STATE OF MAINE  
DEPARTMENT OF AGRICULTURE, CONSERVATION & FORESTRY  
LAND USE PLANNING COMMISSION  
22 STATE HOUSE STATION  
AUGUSTA, MAINE 04333-022

February 4, 2021

The Land Use Planning Commission has continued its review of Wolfden Mt Chase, LLC.'s petition (ZP 779) to rezone 528.2 acres in T6 R6 WELS to a Planned Development subdistrict (D-PD) for the purpose of metallic mineral mining. Commission staff have also solicited review on aspects of the petition from other state agencies and independent consultants. In this review, Commission staff have identified areas where additional information is needed to complete review of the petition. Please submit the following as soon as possible, but at least within 60 days of the date of this letter. Please bear in mind that, depending on the materials that are submitted, additional questions and information requests may be forthcoming as the Commission, other state agencies, and the independent consultants reviewing the response to this letter.

**Linkan Comment #07, Page 39**

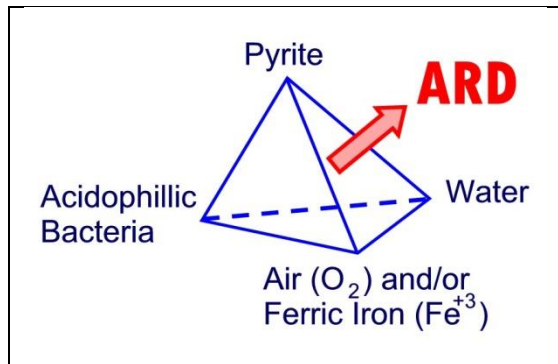
The level of pyrite in the ore (45% to 65%) will increase in the tailings when the minerals of value (chalcopyrite [Cu], galena [Pb], and sphalerite [Zn]) are recovered. By inspection, this elevated level of pyrite in the mine waste has an almost certain likelihood of generating ARD if mitigation measures (discussed elsewhere in the PEA) are not implemented. The arsenopyrite, tetrahedrite, and tennantite in the ore (and presumably the tailings) are potential sources of arsenic and antimony contamination. Mitigation measures are discussed elsewhere in the PEA.

Figure 7.5 Cross Section of the Pickett Mountain Deposit

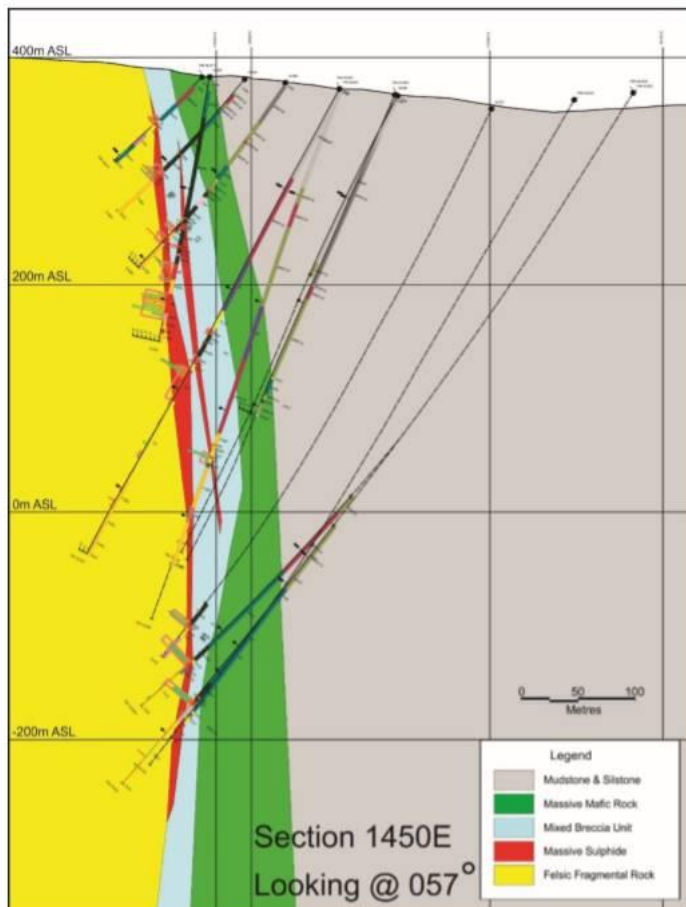
4.	Section 5.5 Physiography	17	It would be useful to discuss surface water bodies and potential impacts to those structures.
5.	Section 7.1 Regional Geology	23	The resolution of Figure 7.2 is hard to read the geology of the region. Please improve the resolution.
